FINAL ENVIRONMENTAL IMPACT REPORT

**SOUTH HAYWARD BART/MISSION BOULEVARD
CONCEPT DESIGN PLAN PROJECT**

SCH No. 2005092093

June 9, 2006

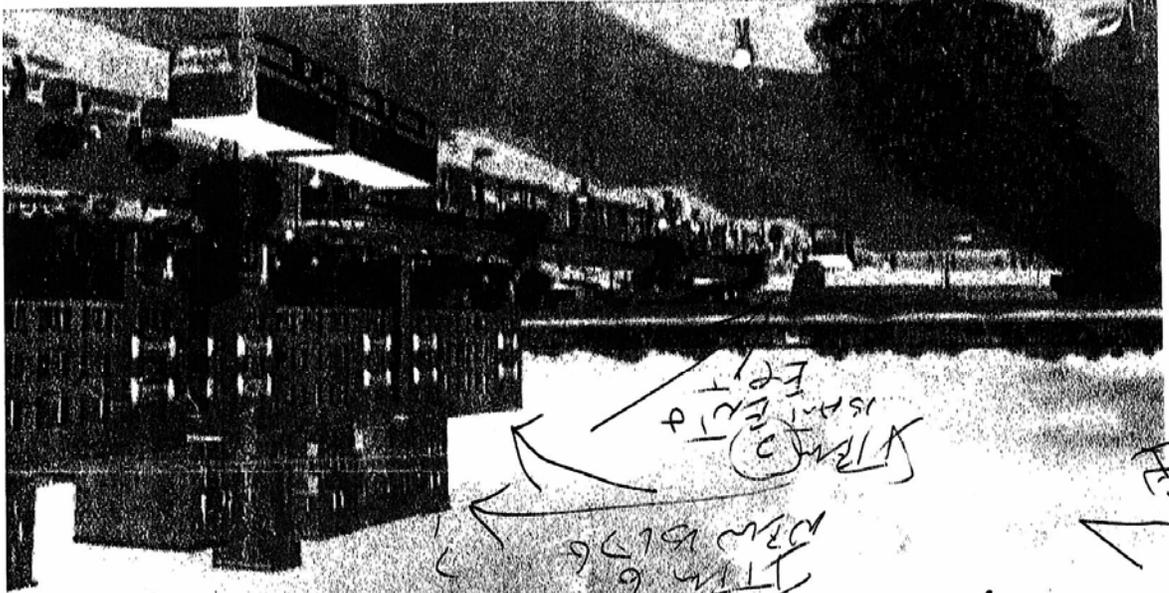
6.1.6
 THINGS FAIL OR GET CHANGED AROUND FOR VARIOUS REASONS OR LOCATION/LOCATIONS MAY I SUGGEST YOU BUILD UP TO A FIVE STORY BLDG ON THE EAST SIDE OF THE NOW SOUTH HAYWARD BART STATION A BUILDING THAT WOULD HOLD FORMER SEX FELLOWS EARLY REL. FOR THE STATE OF & OTHER STATES???? THIS BLDG. WOULD BE BUILT & PAID FOR BY THE DEPT. OF CORRECTIONS & HAVE A VERY MINIMUM SECURITY & THREAT AS THE FORMER SEX FELLOWS & OTHERS WOULD HAVE ONLY ACCESS VIA ASWIPE THE WOULD HAVE THEIR OWN VERY SMALL ROOM TO COME & GO AS THEY PLEASE & ONLY FOR A FEW WEEKS TO A FEW MONTHS TILL THEY MOVE AWAY GET JOBS & TAKE MASS TRANSIT TOGETHER TO THEIR NEW FOUND LIFE & GAIN FULL EMPLOYMENT & LIFE TO INCLUDE GOING TO SOME TYPE OF CHURCH LIKE MISSION MINI TRIES ON 12 St. & off of Tenn. Prd. & MISSION BLVD. IF ANY OF THESE NOW & FORMER STATE PRISON PEOPLE (SCREW UP) & OR DO NOT COME IN A FEW DAYS TO ONE & HALF WEEKS THE ROOM IS CLEARED OUT & CLEANED & THE NEW RESIDENT TAKES OVER MEALS COULD COME MON-FRI & EXTRA MEAL FOR THE WEEKEND VIA SPECTRUM OR SOME OTHER AGENCY AS THEY WOULD HAVE A SMALL MICRO WAVE & REF. & SHOWER TO TAKE A SHOWER OR TURN THE LIGHT BULB ON & OFF AS THEY WISH/WISHED

6.1.7 THE ABOVE BLDG, COULD BE SHARED WITH OTHERS SR. CITIZ (LOW INCOME) OR THE MENTALLY OR VISUALLY CHALLENGED OR RESTRICTED I WOULD THINK THIS WOULD BE A COOEAS NO BODY REALLY LIKE LIVING JUST FROM A BART RAIL LINE & A BUS TRANSIT AREA 477, & ALICE ST 50'

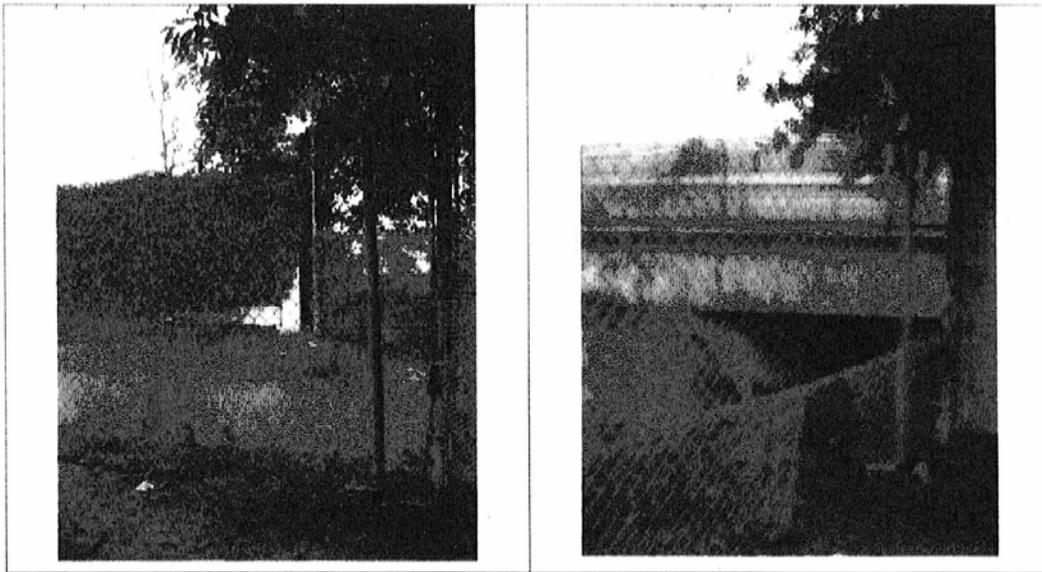
Currently Ziele Creek and its tributary branch along and under Kmart and McDonald's are concreted in and fenced off. The possible restoration of Ziele creek in Sub area 1 is never mentioned or discussed in the Draft EIR despite the fact that the creek is restored under one alternative but not others and it is part of the 100-year flood plain.

The creek is current completely inaccessible. What should be an amenity to the area, as a linear park and point of visual interest, has been transformed into an eyesore. It attracts dumping instead of walkers and joggers from nearby neighborhoods.

Children already illegally cross the creek at the site of the proposed walk/bike path. I observed one go through a hole in the fence, cross the creek on the BART bridge and climb over the ivy-covered wall. This unofficial crossing is somewhat dangerous and the proposed walk/bike path would be far safer and for the children who currently cross.

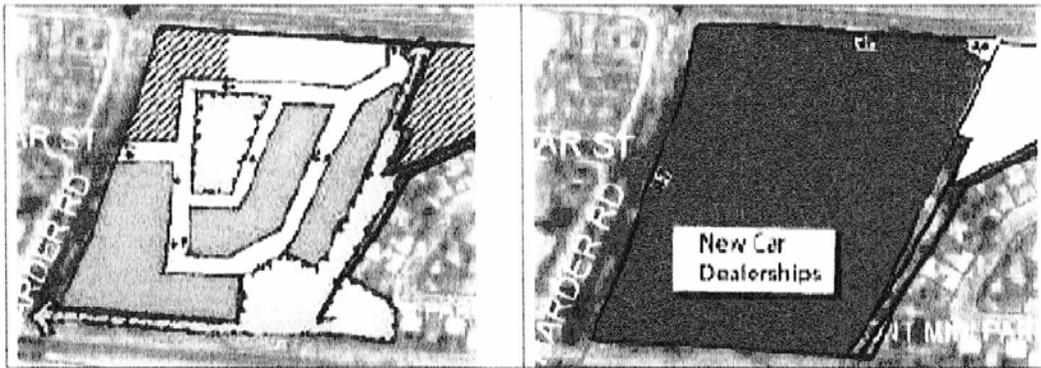
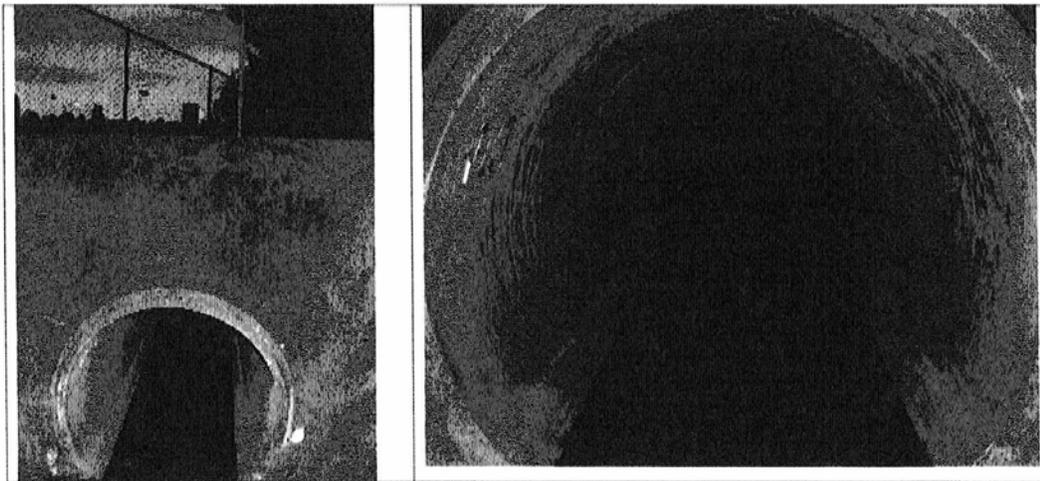
Crossing Mission Blvd. into Holy Sepulture Cemetery the creek is very different. Here instead of being concreted in it was preserved. It creates an oasis of green and shade. A viewing platform allows cemetery visitors to stop and appreciate the creek. With the proper daylighting and restoration work the rest of Ziele Creek, and its tributary, can be restored between Mission Blvd. and the BART tracks.

The creek is restored as part of a larger park and walkway system under the Urban concept alternative (left picture). Under the other alternatives the entire site is devoted to car dealerships with no habitat restoration or walking paths between the adjacent neighborhoods (right picture). This is not addressed at all in the text of the DEIR. None of the alternatives propose restoring the creek from the Kmart property line to Mission Blvd leaving that section between the cemetery and the Kmart site in concrete even if the rest is restored.

Finally, the tributary of Ziele Creek that runs from the back end of the McDonald's property under the Kmart parking lot to the intersection of Harder and Mission is never mentioned. Daylighting and restoring this creek section would provide an excellent greenway from the intersection through the proposed mixed-use development to the Ziele Creek greenway. It would also provide a green focal point for the creation of a new mixed-use neighborhood on the old Kmart/Payless site.
